# **Council Assessment Report**

**2015STH021 (DA2015/789)**

**Medical Centre & Pharmacy**

**46-50 Underwood Street Corrimal**

## PALLISADE FENCING

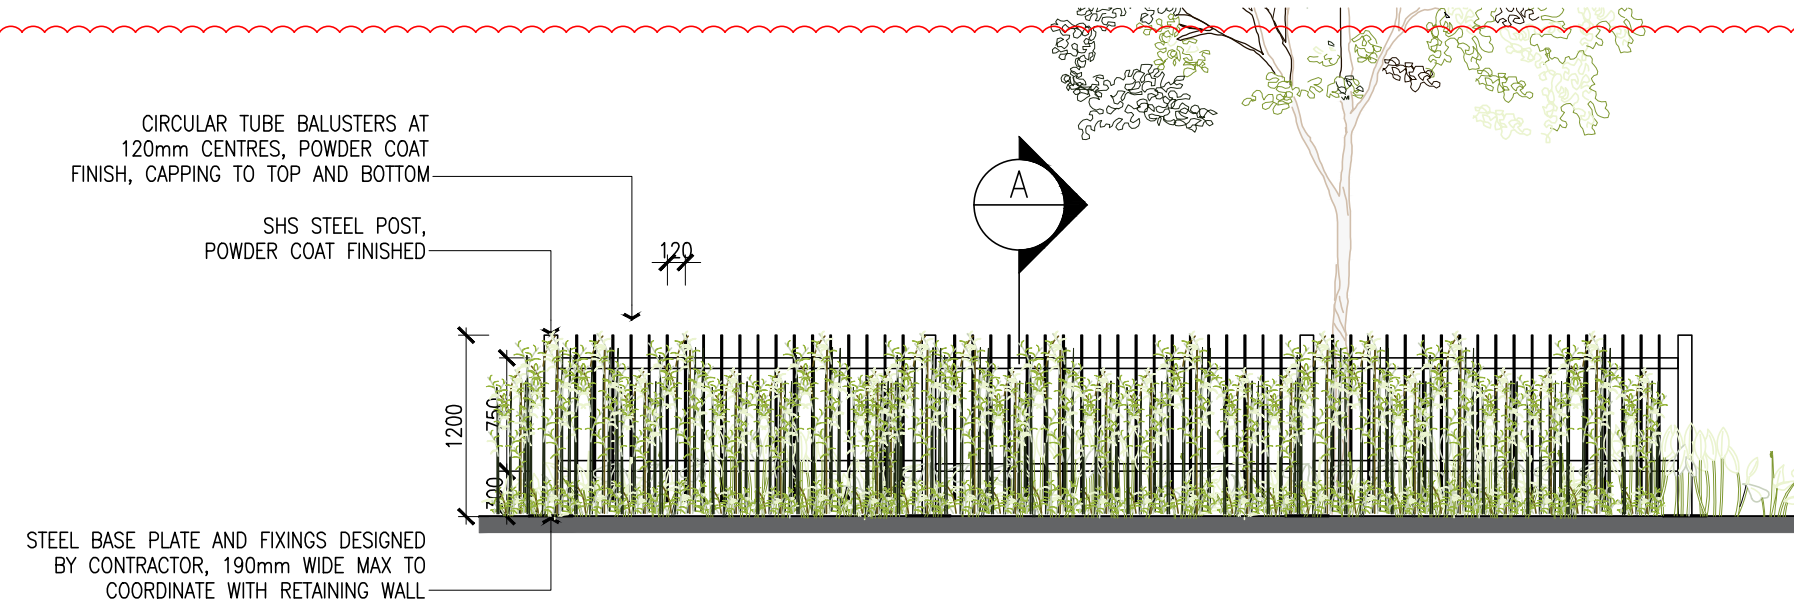
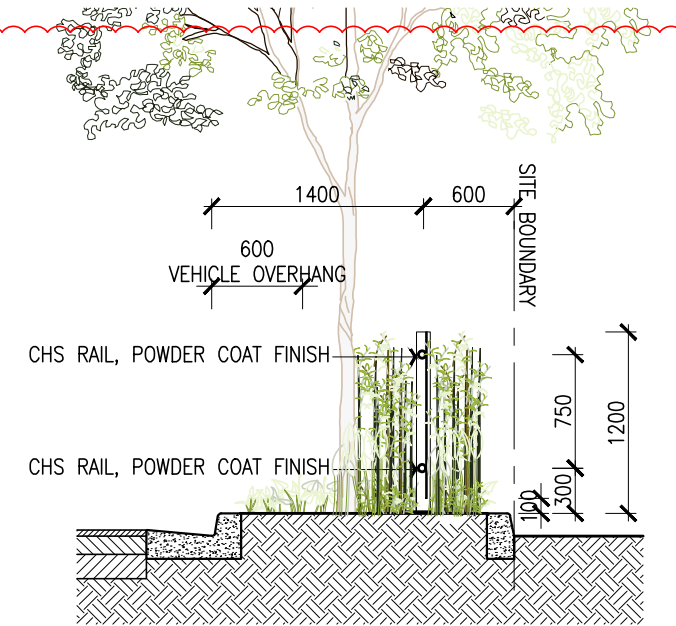
- *The submitted revised fence details are a significant improvement from the previously proposed 2 metre high boundary fence.*

Drawing Name:  
**Landscape Plan**

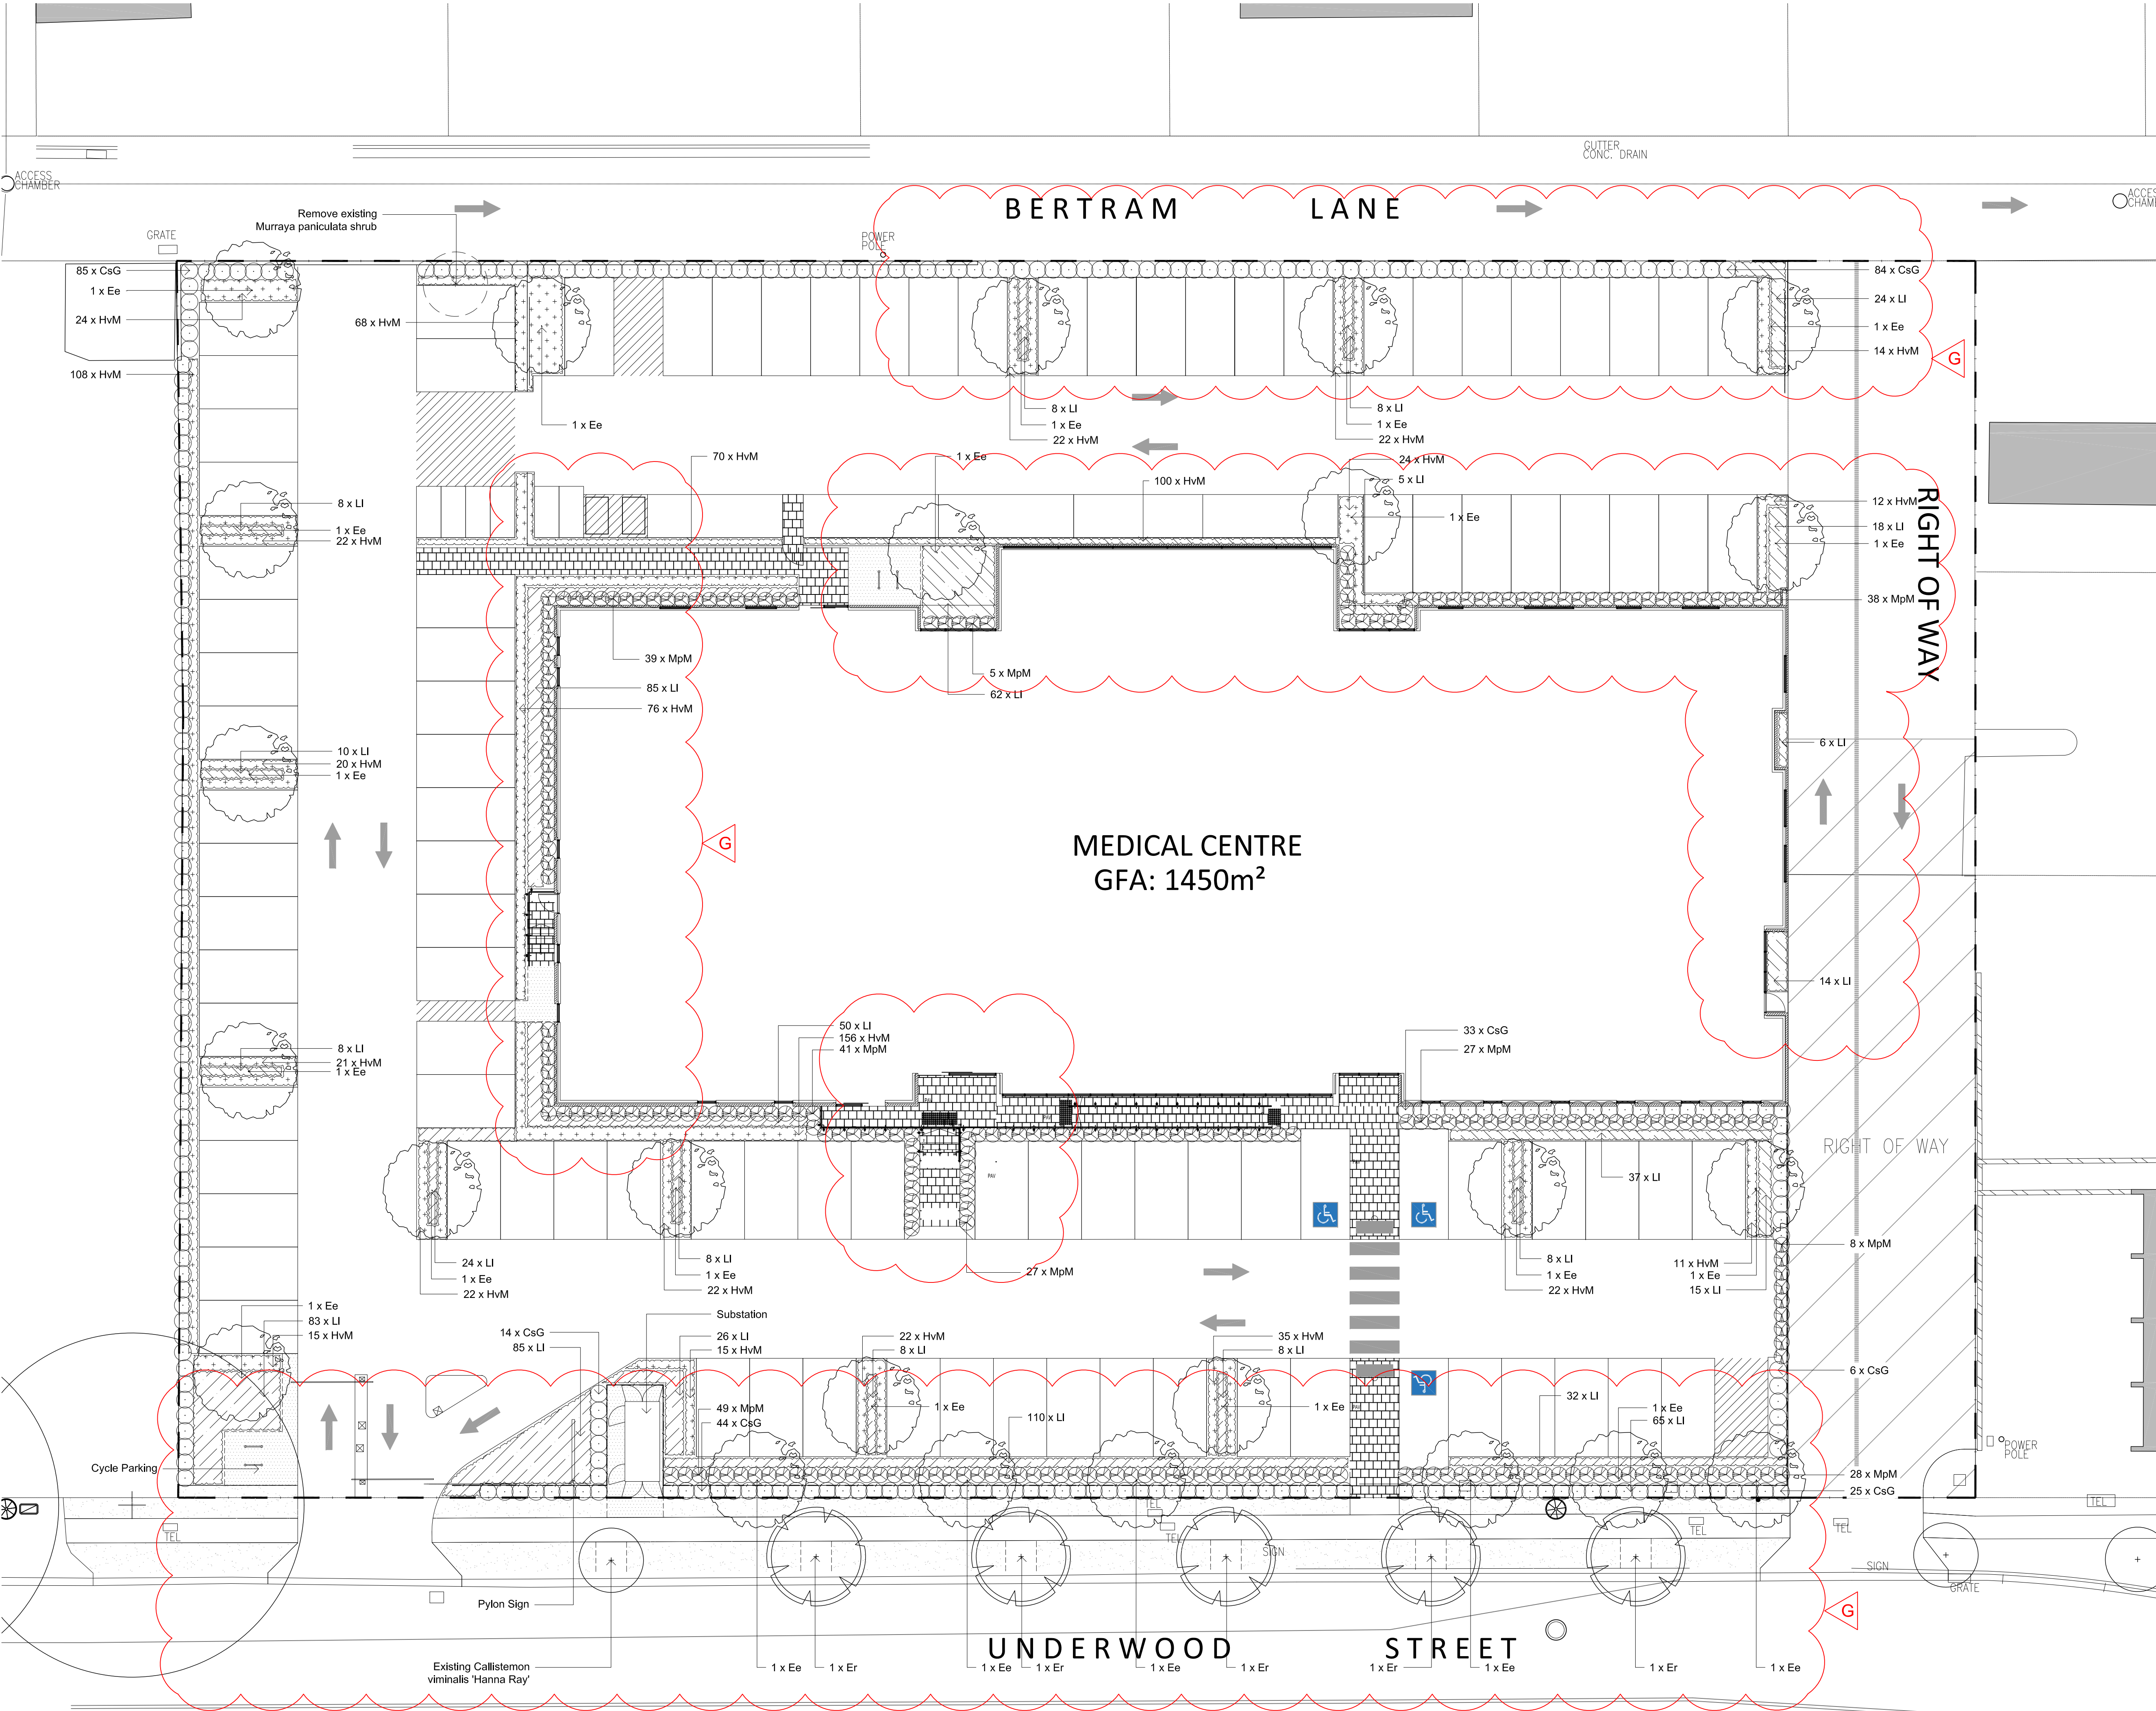
*"Although proposed landscaping is in garden bed of less width than what is required in DCP, 2m rather than 3m, plans submitted meet objectives to provide screening and amenity. A row of street trees is proposed along Underwood Street and with absence of power lines these have the potential to reach mature height. These trees are to be *Elaeocarpus reticulatus* Blueberry Ash which is a commonly used street tree. Offset from the street trees in staggered pattern are additional tree planting of *Elaeocarpus Eumundi* a similar tree. Tree planting is also included in garden beds within parking area giving affectively three rows of threes. These trees have potential to be crown lifted to*

Recommended conditions include requiring that the westernmost row of car parking adjacent to Underwood Street be constructed using permeable paving to ensure that the tree root zones of the proposed plantings will have sufficient growth room, the submission of a final landscape concept plan and certification of consistency between the final landscape plan and stormwater plan for the site. Councils Stormwater and Traffic Officers have also been consulted with regard to the recommended conditions, particularly the requirement for permeable paving. No adverse stormwater or traffic impacts are envisaged as a result of the recommended landscape conditions.
